STAFF REPORT WEST ALLIS PLAN COMMISSION Wednesday, September 25, 2018 6:00 PM

- 2A. Special Use Permit for a proposed hotel to be located at 1010, 1040 & 1126 S. 70 St., submitted by Kraig Sadownikow, d/b/a 70th Street Hotel Associates, LLC.
- 2B. Site, Landscaping and Architectural Plans for a proposed hotel to be located at 1010, 1040 & 1126 S. 70 St., submitted by Kraig Sadownikow, d/b/a 70th Street Hotel Associates, LLC. (Tax Key No. 439-0001-026)

5 SOUTH BUILDING ELEVATION

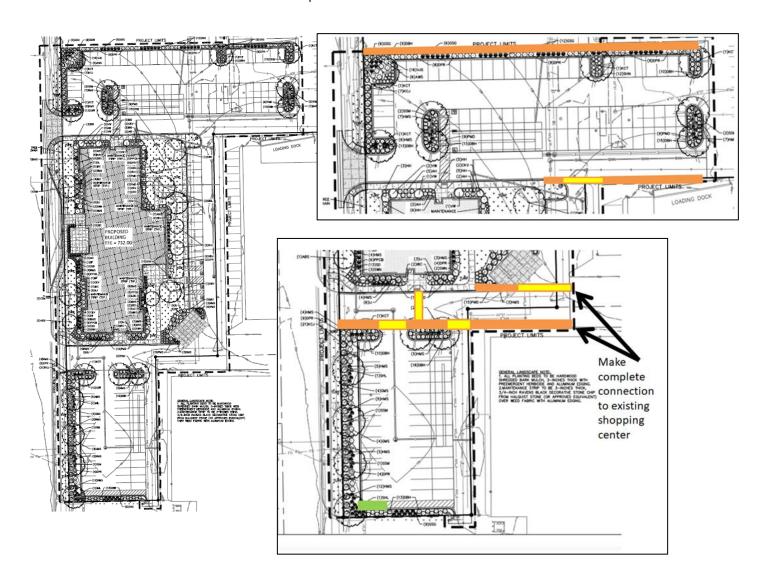
Proposed building materials are comprised primarily of black brick around the base, pewter brick, and pewter hardiepanel siding. Additionally, the Home2 Suites beacon, which indicates the building's main entrance on the east side, will be made with laminated, heat-treated glass in shades of blue and green. In the previously approved architectural plans, a series of full-height metal panel proportions (matching the black brick) were included. This variation has been removed from the current plans, and staff recommends the metal panels be added back in as a primary building material.

Staff recommends additional windows be included on the north and south elevations, as well as to the pool area on the building's east side, to be consistent with the previously approved plans.

- 1. Revised Site, Landscaping, and Architectural Plans being submitted to the Department of Development to show the following: (a) additional windows added to the north, south, and east elevations; (b) inclusion of metal panels in the building materials; (c) building height details consistent with previously approved plan; (d) PTAC details shown on plan; (e) staff approval of material and color samples; (f) traffic flow; (g) pedestrian travel areas; (h) inclusion of additional sidewalks and pedestrian crossings, as approved by staff; (i) additional landscape area in the southwest corner of the site; (j) adjustments to the refuse enclosure area, as needed; (k) additional streetscape elements (may include lighting, planters, benches, colored concrete, narrowed drives, bump-outs, etc.) which are consistent with overall West Quarter development plans and as approved by staff; and, (l) City Forester approval of the landscaping species and number. Contact Katie Bennett, Lead Planner at 414-302-8463.
